Safety Defect and Noncompliance Report Guide for Equipment
PART 573 Defect and Noncompliance Report¹

Generic name of the item: HURRICANE HOT WATER HEATER
Make: _____ Model: MODEL CO 20/32/45/65/85/105/145XL
Part Number: _____ Size: _____
Function: HOT WATER HEATER
Other information which characterizes/distinguishes the items of equipment to be recalled:

Part III: Description of Defect

Figure 1: Additional Control Circuit Schematic

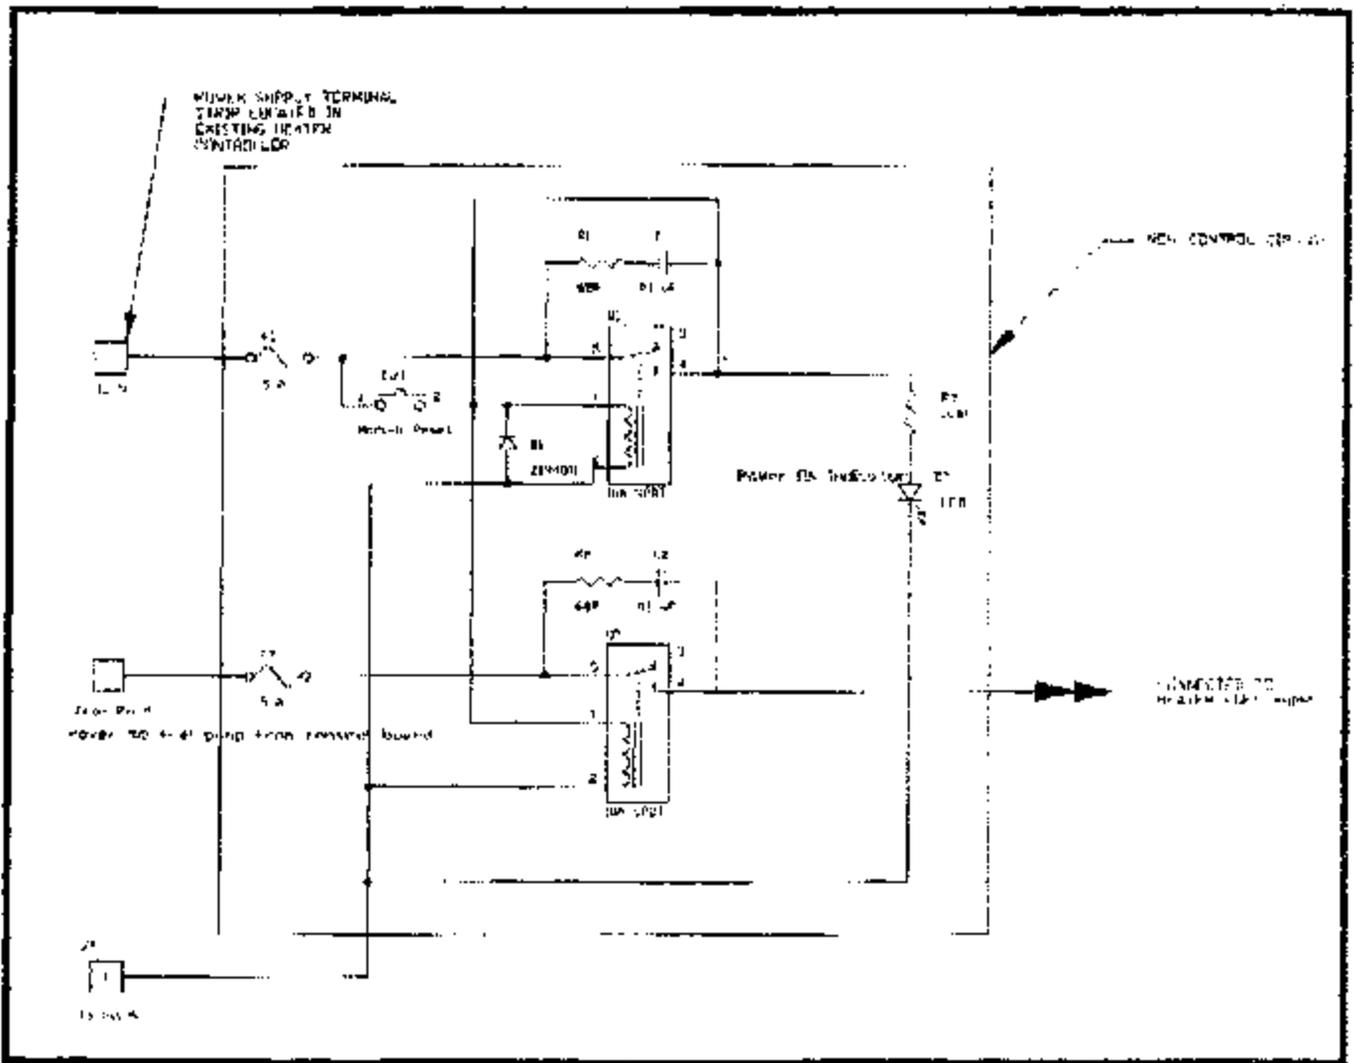
A safety concern has been identified regarding the Hurricane Heater Systems installed in various motor home coaches requiring immediate attention. The concern relates to a defective IC chip located on the circuit board of the heater control board that may be damaged by a transient voltage spike. The control board is a component that is installed within a heating system that burns diesel fuel to heat water for a hydronic heating system and potable water. If this IC chip fails, a condition may exist where the heating system will not shut down and heating will continue. After a time all the coolant (water & anti-freeze) turn to steam. Continued operation of the heating system may result in a fire, which can cause personal injury or property damage.

The concern relates to the potential failure of electronic components located in the electronic control board. This deficiency may result in the potential failure of the heater to detect an overheat situation causing the heater not to shut down.

The solution requires the installation of an additional control circuit to the existing control system. This new circuit provides an additional mechanical safety overheat mechanism which operates independently of the heater controller.

In the event of condition where the high temperature set point has been reached, the contacts in the high limit sensor will open, causing a relay in the new circuit to shut off power to the fuel pump. This will cause the heater to flame out and stop. The heater cannot be restarted until a manual reset button has been activated. An indicator status light will go out if the overheat relay has been deactivated.

If the relays were to fail, they will fail in an open condition, which will not provide power to the fuel pump. There is a 5 A fuse inline with the power to the fuel pump. This is to keep the contacts of the relay from fusing if the fuel pump ever shorts.

This new control circuit will be connected by a electrical cable to the existing heater controller and located close proximity.
